PIVOTAL COMMWARE

Application for Experimental Authority

File No. 0995-EX-CN-2018

Supplemental Information

Exhibit 1
Antenna Patterns

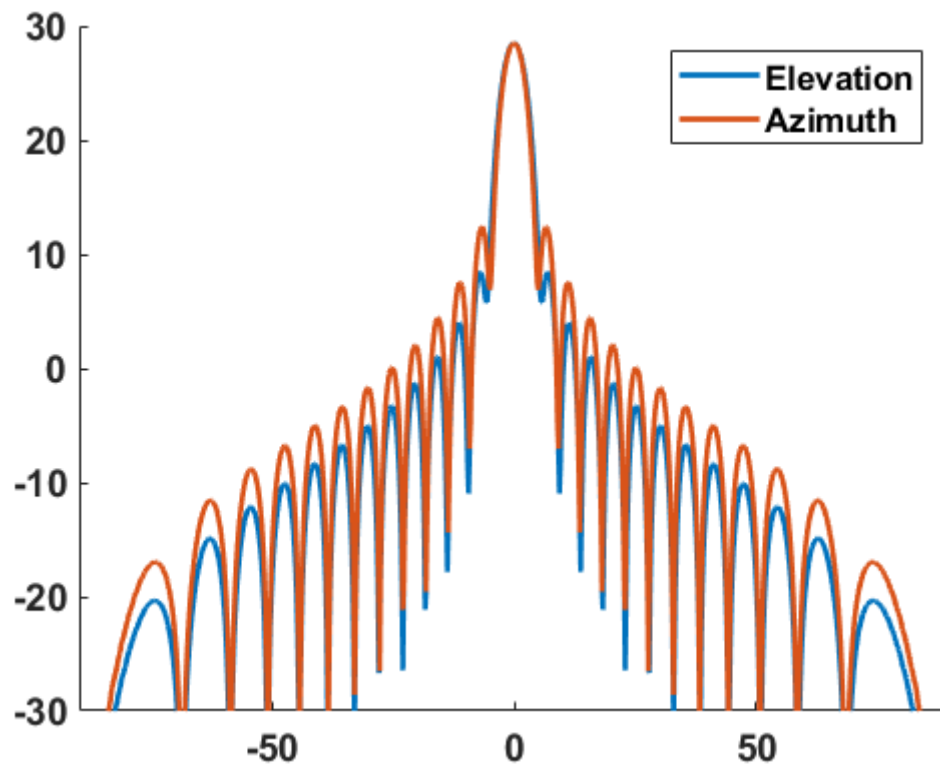
Question 2B: Please submit the antenna pattern performances.

See Exhibit 1 for a computer-generated antenna pattern. Applicant seeks experimental authorization to conduct "real-world" testing, and among other things, to generate real-world antenna patterns.
